project: BRUNSWICK MILL DEVELOPMENT PHASE 1

title: LEVEL 3 PROPOSED

drawing number: L(20)203

status: STAGE 5 – CONSTRUCTION

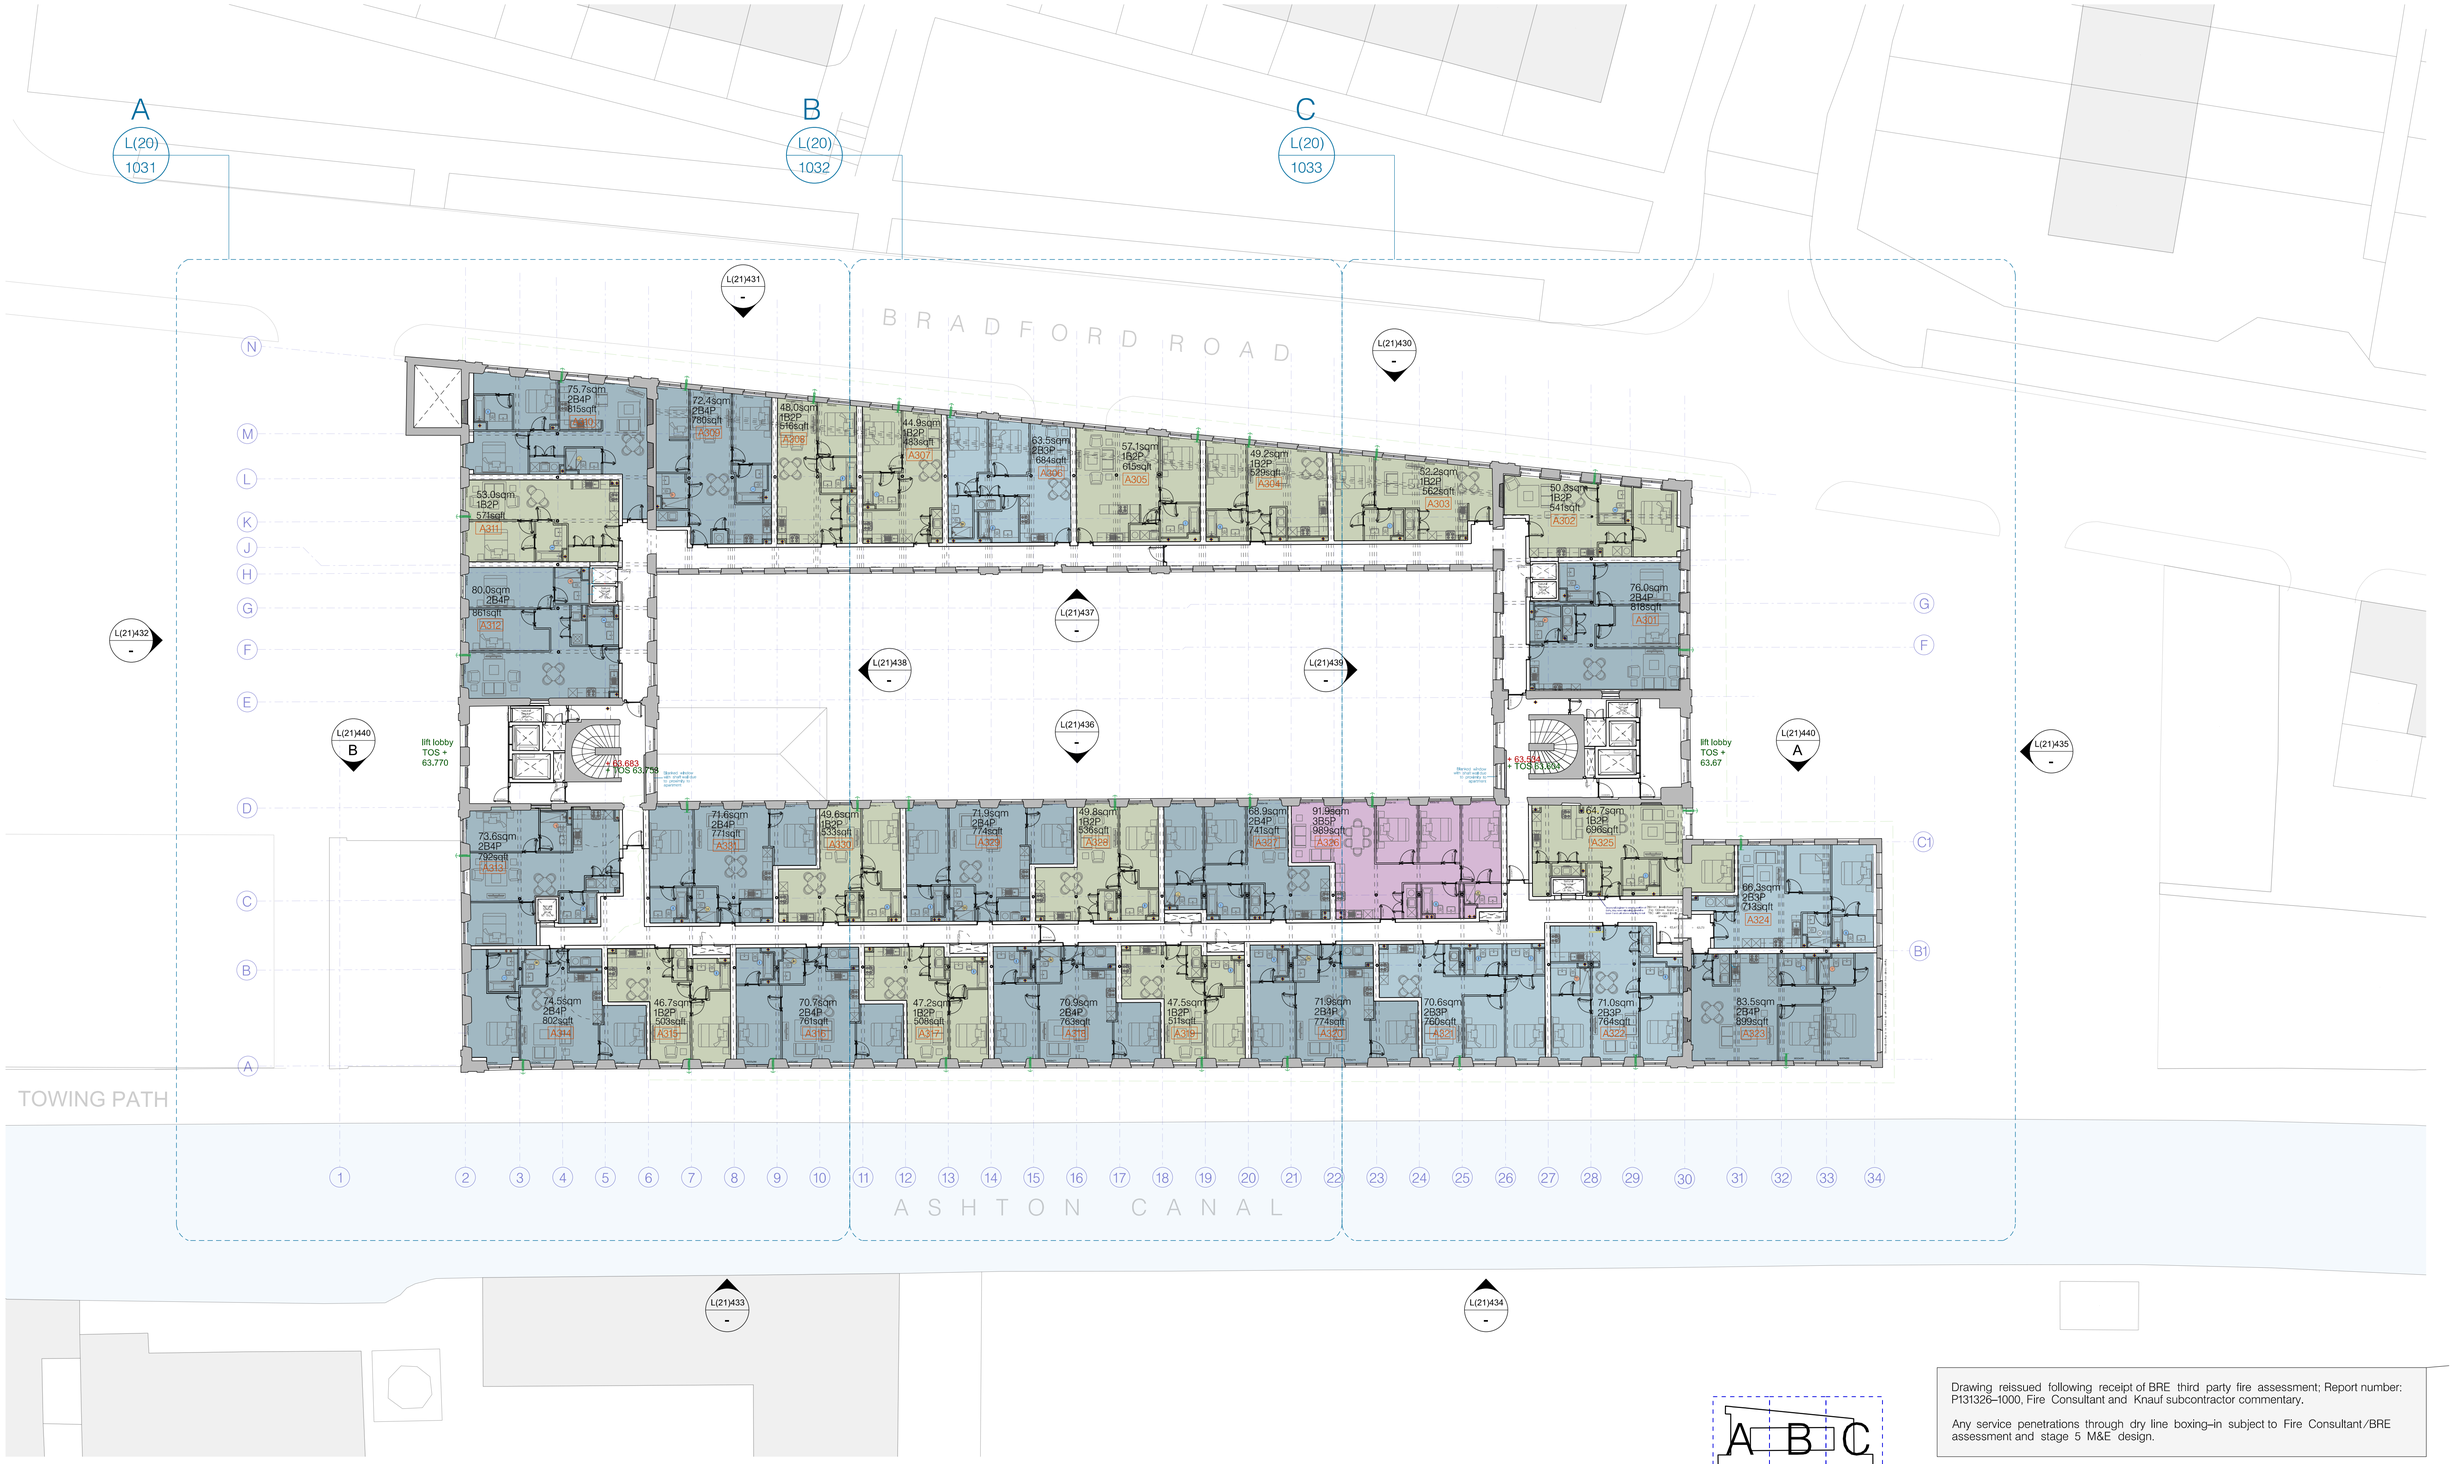
CONSOLUX TO REVIEW ALL SVP SET OUT - SPACE BEHIND SHOWER SPACE. SPACING INBETWEEN SVPS FOR STRUCTURAL CORING. & N/E UNIT KITCHEN CHANGE. CONSOLUX TO UPDATE DWGS TO ALLOW FOR REFERENCE INTO ARCHITECTURAL DWGS
